PROPOSED DEVELOPMENT at WOONTON FARM . LOGASTON RD.
WOONTON . for MR & MRS BAKER

PLOTS 4 & 5

D1808.6G

FIRST FLOOR PLAN

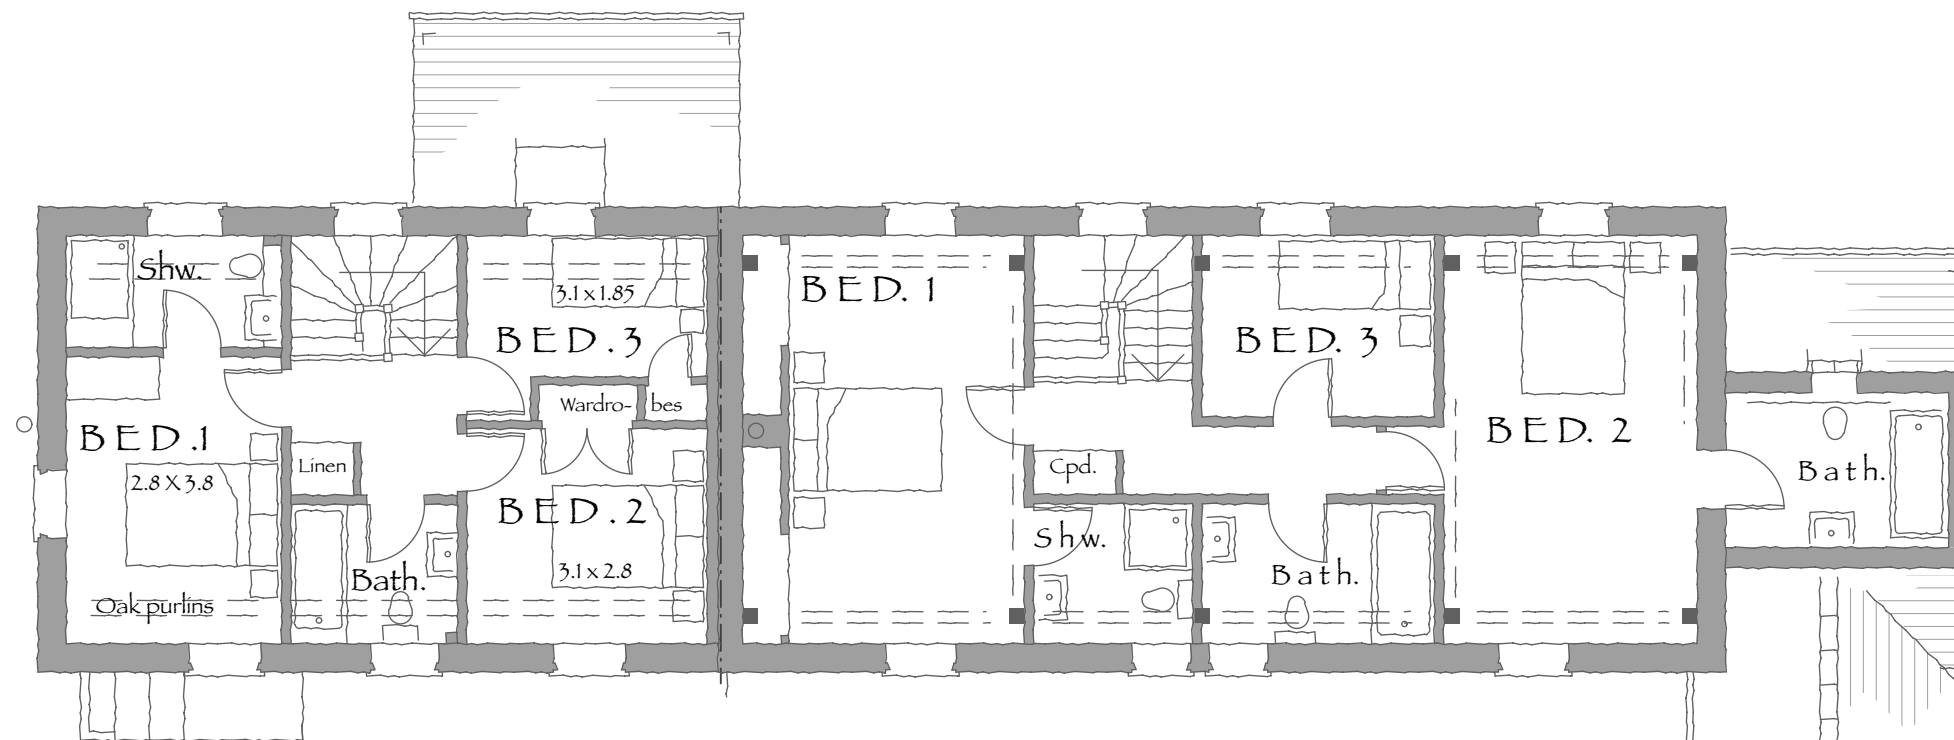
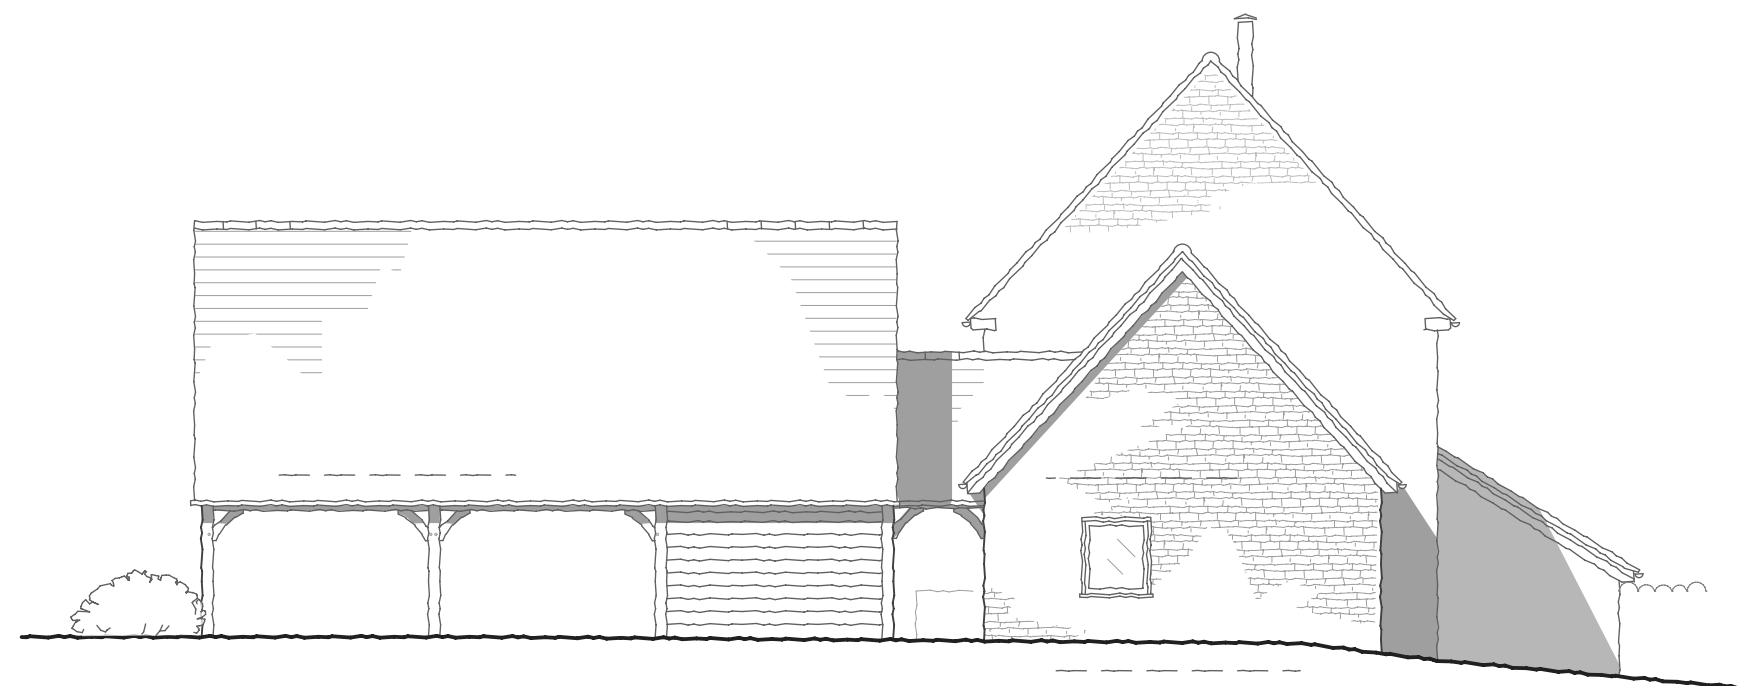
Revision F:9.3.22 Wall thicknesses amended to accommodate stone, plot 4 flue moved to outside, room layout amended to open up hall, first floor oak posts removed, subdivide bedroom & add shower rm. in plot 4, reduce cupboards, remove wc & fireplace in plot 5 G:28.6.22 Stone gable removed from car port
